<b>Model</b>	ST10	<b>Volt/Hz</b>	<b>Date of Modification</b>	<b>Serial Number</b>
<b>Modified Article</b>	Bin Drive Motor, Main Board			
<b>Reason for Modification</b>	To meet the CE Mark standards.

Model: ST10		Date: 15-Apr-97	No: 4
Modified Article: Stapler		Prepared by: S.Hizen	
From: QAC 1st Field Information Dept.		Checked by: T. Inoue <i>T. Inoue</i>	
Reason for Modification:	<input type="checkbox"/> Parts catalog correction <input type="checkbox"/> Vendor change <input type="checkbox"/> To meet standards <input type="checkbox"/> To facilitate assembly <input type="checkbox"/> To improve reliability ( ) <input checked="" type="checkbox"/> Part standardization <input type="checkbox"/> Other

Model: Phoenix-10bin -S/S		Date: 21-Nov-01	No.: MA555006
Modified Article: Anti Static Brush		Prepared by: M. Kitajima	
From: Technical Services Dept., GTS Division			
Reason for Modification:	<input type="checkbox"/> Parts catalog correction <input type="checkbox"/> To facilitate assembly <input type="checkbox"/> Part standardization	<input type="checkbox"/> Vendor change <input checked="" type="checkbox"/> To improve reliability <input type="checkbox"/> Other	<input type="checkbox"/> To

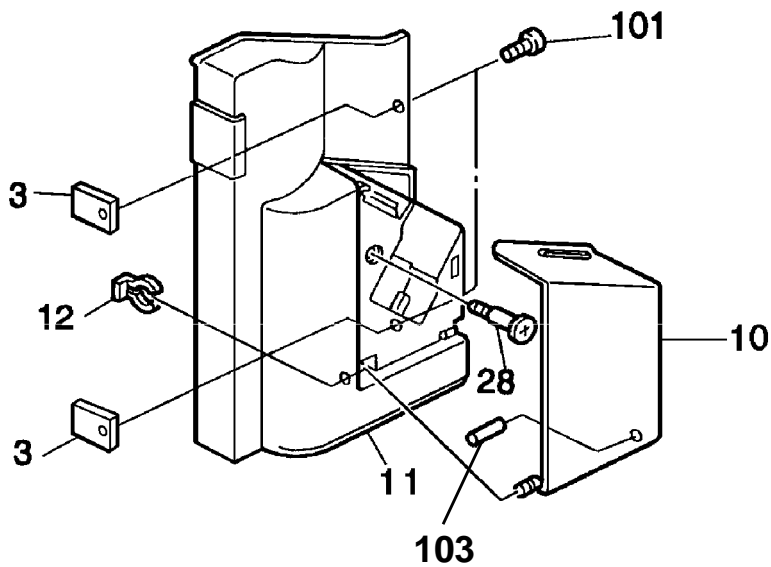
Old P/N	New P/N	Description	Q'ty Used	Inter-change-ability	Parts Catalog	
					Index No.	Page
AX06 0110	AX06 0122	Bin Drive Motor	1 → 1	X/O	6	9
A555 5100	A555 5105	Main Control Board	1 → 1	X/O	4	11

NOTE: In markets other than Europe, the interchangeability is O/O.

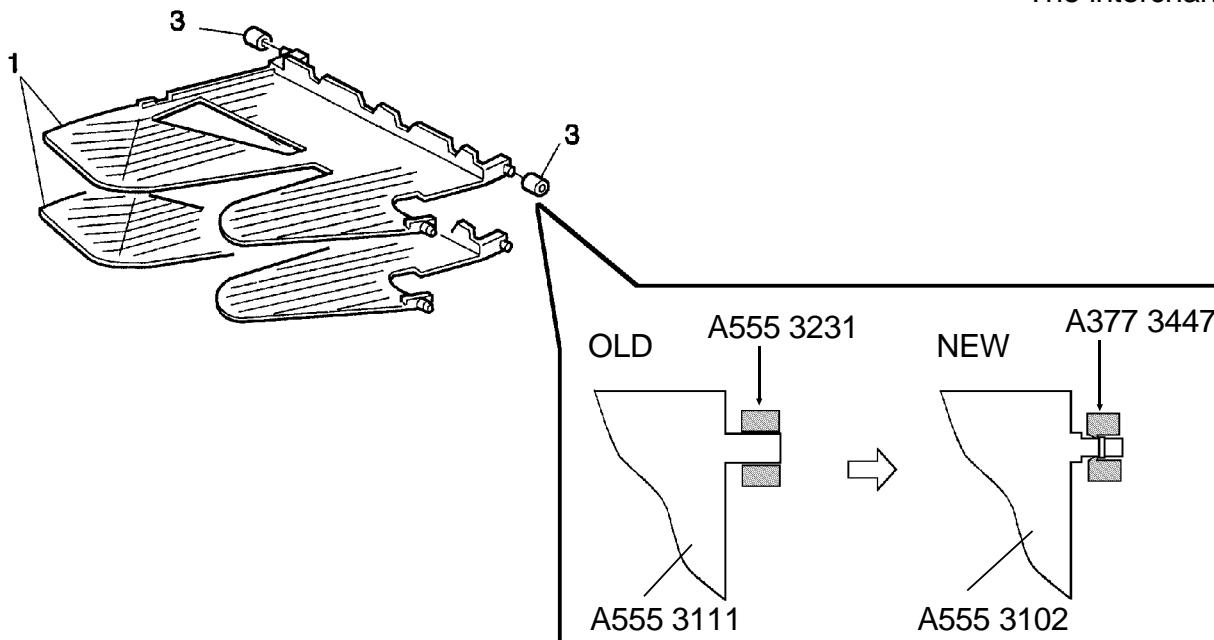
<b>Model</b>	ST10	<b>Volt/Hz</b>	<b>Date of Modification</b>	<b>Serial Number</b>
<b>Modified Article</b>	Bin, Bin Guide Roller			
<b>Reason for Modification</b>	The Bin Guide Roller and the bin have been changed to simplify the assembly.

Old P/N	New P/N	Description	Q'ty Used	Inter-changeability	Parts Catalog	
					Index No.	Page
A555 3111	A555 3102	Bin	11 → 11	X/X	1	9
A555 3231	A377 3447	Bin Guide Roller	22 → 22	X/X	3	9

The interchangeability as a set is X/O.

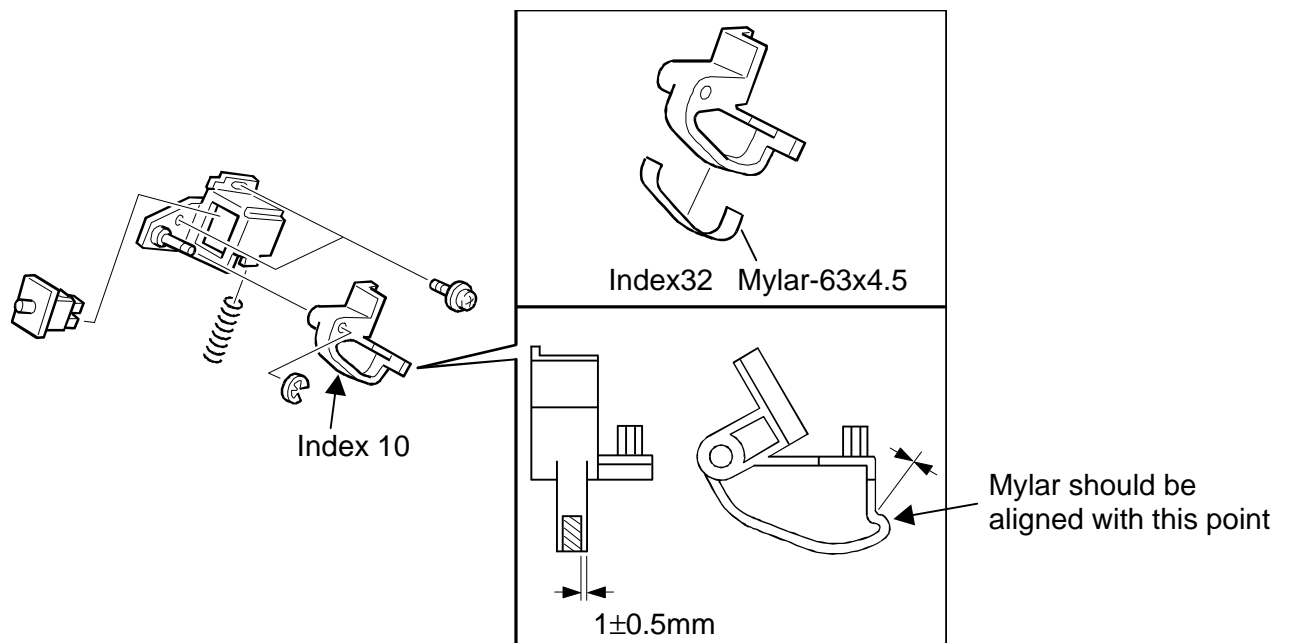
Old part number	New part number	Description	Qty	Int	Page	Index	Note
A5553182	A5553187	Stapler Actuator Switch	1- 1	X/O	7	10	
	A5553186	Mylar – 63x4.5			7	32

The Mylar #A555-3186 has been added to the Actuator Switch to prevent noise.

The part #A5553187 is for the assembled part (Stapler Actuator Switch with the mylar).

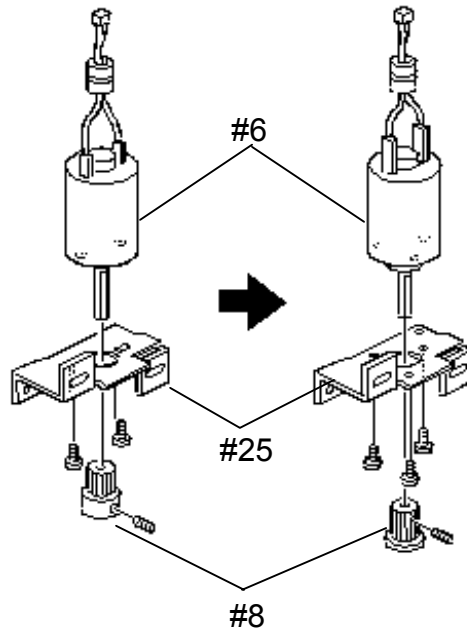
To prevent the brush from coming out, the material of the plate for the antistatic brush has been changed from carbon to SUS.

Old part number	New part number	Description	Q'ty	Int	Page	Index	Note
A5552161	A5552166	Anti Static Brush	1	X/O	3	22
